Product Change Notice (PCN)

Subject: Tape & reel packing change for R8C/3x & R8C/M13B LQFP 32pin & 48pin products

Publication Date: 4/23/2024

Comparison of tape & reel material details: 7x7mm LQFP Tape & Reel packing

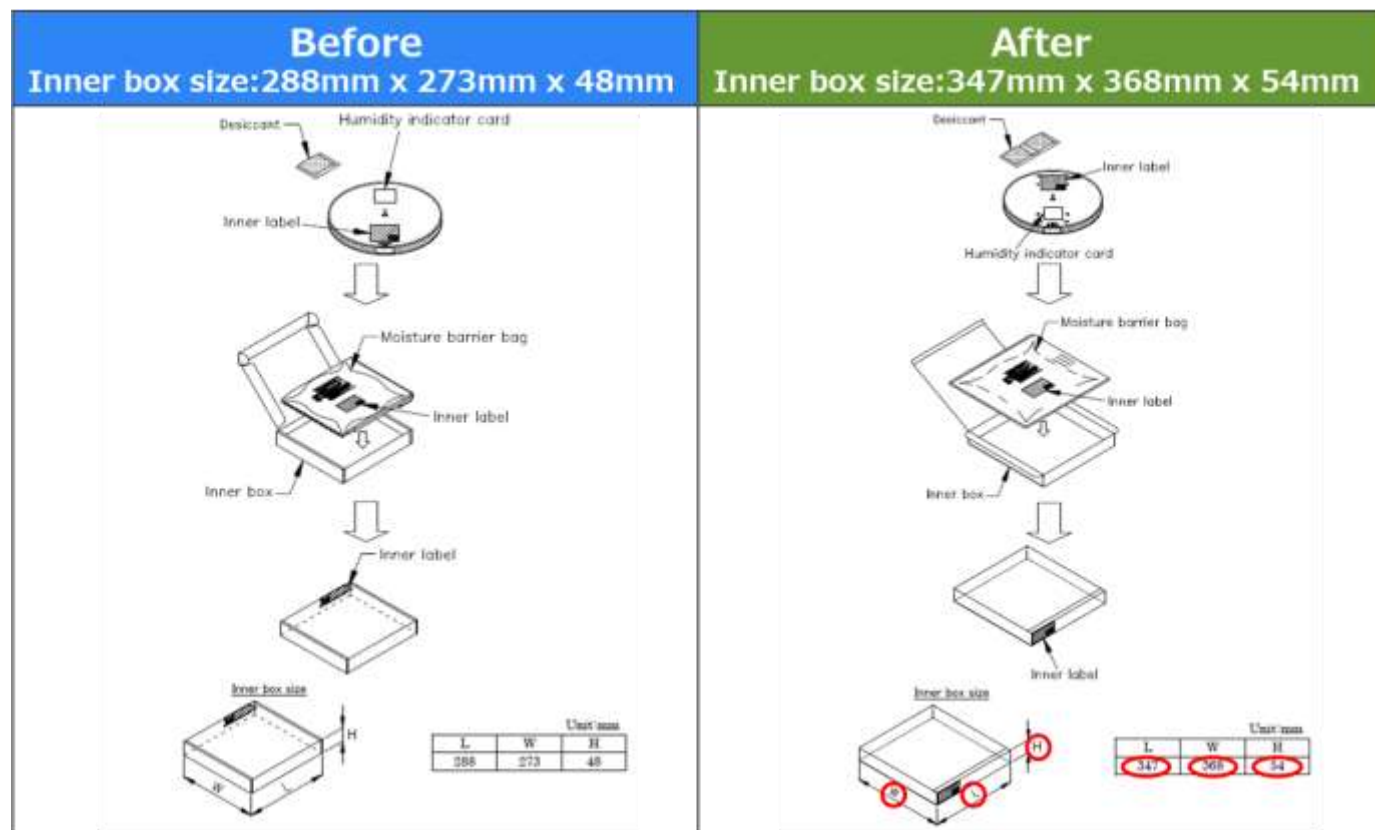
Packing material	Item	Before	After
Emboss tape	Taping code	E1612Q07RA	E1612Q07RA
	Sprocket hole	One side	One side
	Tape width	16mm	16mm
	Tape thickness	0.3mm	0.3mm
	Cavity size	9.5x9.5	9.5x9.5
	Cavity depth	1.4mm	1.4mm
	Distance between cavity centers	12mm	12mm
	Material	PS	PS
Reel	Reel diameter	254mm	330mm
	Core diameter	100mm	100mm
	Reel width	For 16-mm tape width	For 16-mm tape width
Desiccant			
Inner box	Length	288mm	347mm
	Width	273mm	368mm
	Height	48mm	54mm
